## 01 Independent Quality Assurance: Post-Pour Inspection

01.2 Independent Quality Assurance: Post-pour / [REDACTED]

Flagged items	7
Inspection type	01.2 Independent Quality Assurance: Post-pour
Job Name	[REDACTED]
Client	[REDACTED]
Site Address	[REDACTED] Australia [REDACTED]
Inspection Date	[REDACTED] 2023
Footing description	Waffle raft
Inspection completed by	[REDACTED]
Weather	8:00am: 14°, Cloudy and windy with a shower in spots, Wind SW 32km/h, Wind Gusts 57km/h

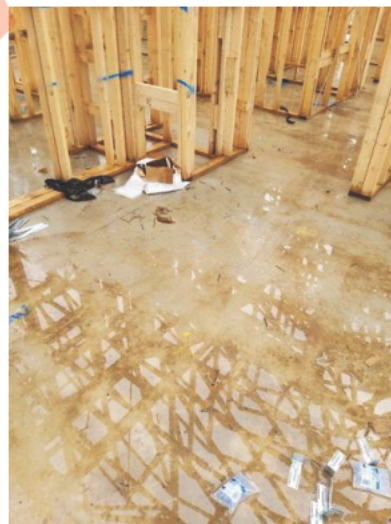
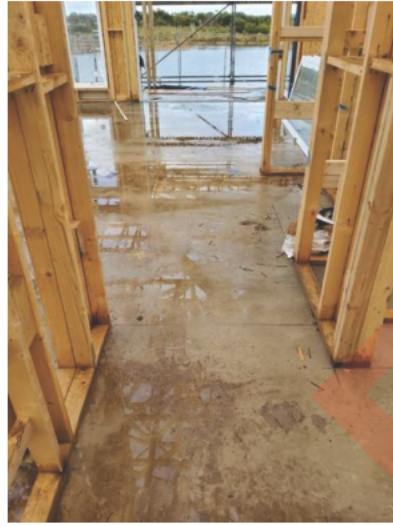
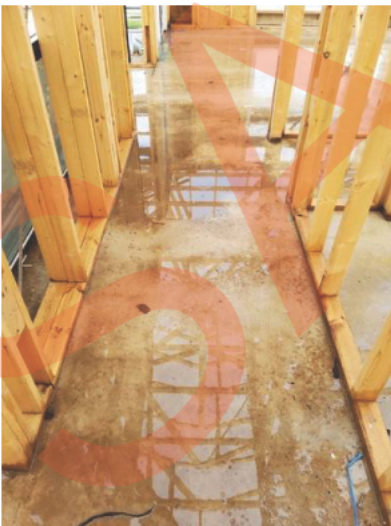
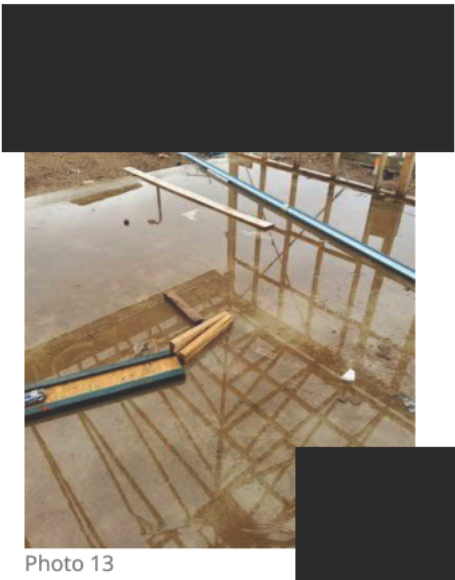
From the levels taken the overall slab exceeds in height, lowest point identified was -15mm and highest identified was +13mm. This equates to 28mm overall to the building which exceeds the tolerance.

Numerous bedrooms also exceed the maximum tolerance of 10mm out of level. These include but are not limited to;

1. Bedroom 27mm (-14mm to +13mm)
2. Ensuite 14mm (+12mm to -2mm)
3. Laundry 13mm (-13mm to 0mm)
4. Family 17mm (-15mm to +2mm)
5. Dining 17mm (-14mm to +3mm)
6. Bed 11mm (-8mm to +3mm)
7. Bed 3. 13mm (-9mm to +4mm)
8. Garage 13mm (-4mm to +9mm)

These areas are also more evident with rain which outlines a number of low/high spots.

Builder to complete their own complete survey and propose with client on how surfaces and levels will be made good, what processes will be involved, what products will be used and get confirmation from RBS that these products and processes are adequate.

The builder should complete their own survey to establish the area's that don't comply with the above tolerance to establish the best method of rectification.

If the builder proposes grinding or using a self-levelling product a scope of works and details are to be provided to the owner prior rectification.
